Part 21 (PAR)

POTENTIALLY UNQUALIFIED COMPONENT IN CERTAIN ALLEN BRADLEY TIMING RELAYS

**UPDATE - Report of potential 10CFR Part 21, Allen Bradley Timing
Relay Model 700RTC
Report No: P21-04302015, Rev. 2**

Part 21 Report No: P21-04302015, Rev. 2

Figure 2 - New design circuit board and CPLD that replaced the original component.

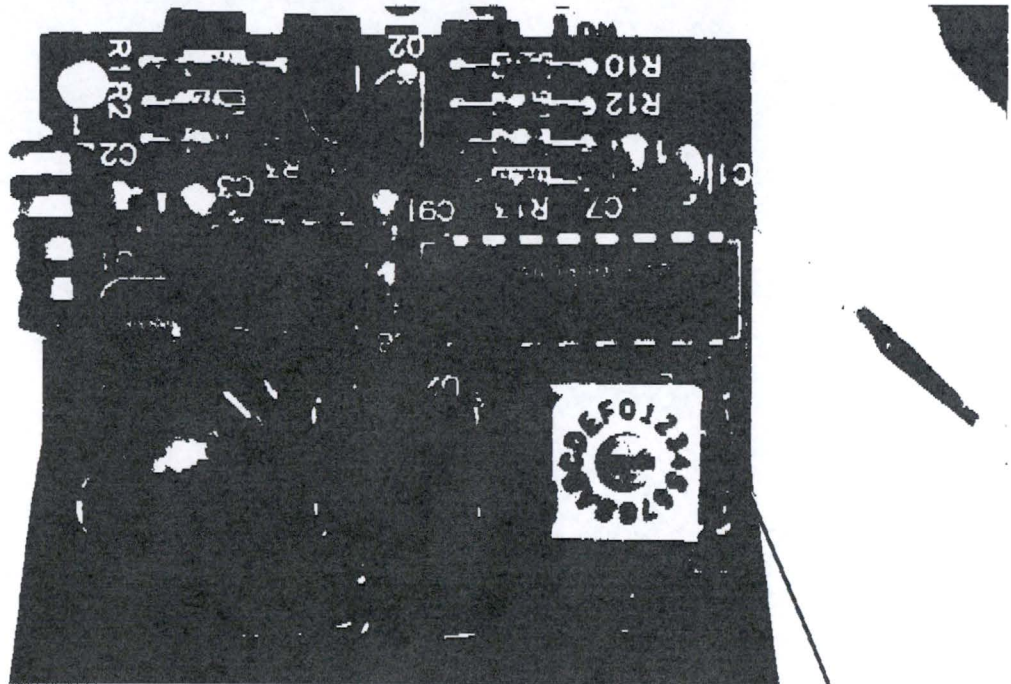
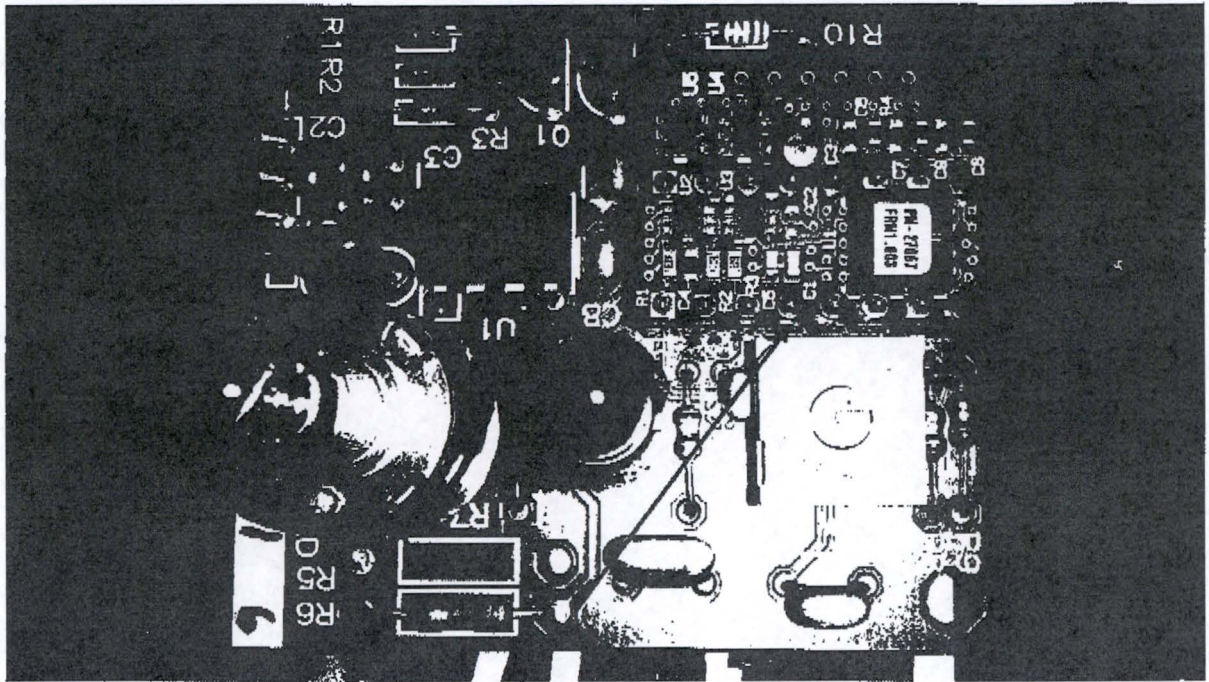
Between 2009-2010, Allen Bradley made a design change without changing the part number of the commercial relay or providing any documented evidence of a design change. The manufacturer specification data sheets maintain the classification that the relays are "solid state", which would imply that there are no digital devices installed in the relay. However, after inspection of the internals of the timing relay (Figure 2), it has been identified that the unit does contain a CPLD which meets the definition of a digital device under the guidance of NEI 01-01. See Figures 1 and 2 below:

Figure 1- Original qualified design (prior to 2009).
Relays supplied prior to 2009 are not affected by this issue.

Original component

The relays that are currently in stock at NLI have been placed on hold until after the units have been determined to be qualified for the specific application. NLI has completed the EMC qualification testing per the requirements of EPRI TR-102323 Rev. 4 for the following tests, as applicable: CE101, CE102, RE101, RE102, RS101, RS103, CS101, CS114, CS115 and CS116.

The results were satisfactory with exception of the following condition: During Conducted Susceptibility CS114 onto the power lines, with the timing circuit in operation, the instantaneous contacts exhibited chatter in the range of 2.6 MHz to 20.3 MHz. The unit requires a ferrite to be installed onto the input power lines of the relay with 3 turns through the ferrite core. In this modified configuration, the relay was not susceptible to Conducted Susceptibility and successfully passed the required test per CS114.
